Grange Park - Comments received after July 7 meeting:

Grange Park Revitalization

2. Zone B - Great Lawn

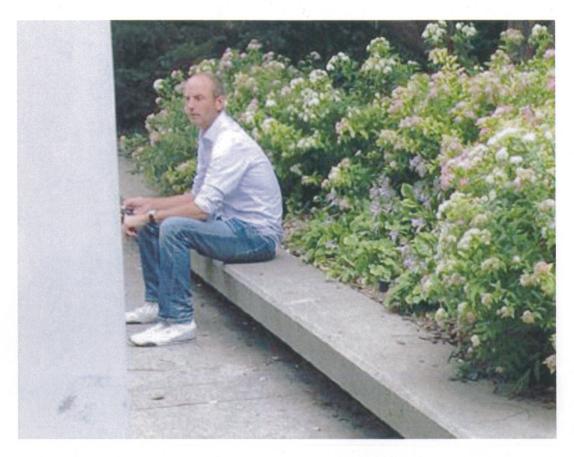
- 2.1 The area must be slightly mounded with highest elevation at the center such that the field drains effectively. Proper drainage can be achieved with drain trenches and drain collectors designed as a component of the walkways at the perimeter of the lawn.

- a) Understanding that the existing soil in this area is compacted and that additional soil will be added and graded, water absorption (multiple winter snow melts throughout winter season on frozen ground soil) is not possible in the winter months.

- b) An irrigation and sprinkler system such as one suitable on a golf course to maintain the lawn throughout the summer months - possible water saving reservoir under the lawn or walkways (below freezing level), collects from perimeter drains and is filtered and used as supplementary water for irrigation system (recycling of site water) - set timer for night time sprinkling.

- c) Mounding of the lawn will facilitate more rapid drainage of the water during heavy rainfalls to ensure a reasonably dry field for use shortly after such soakings.
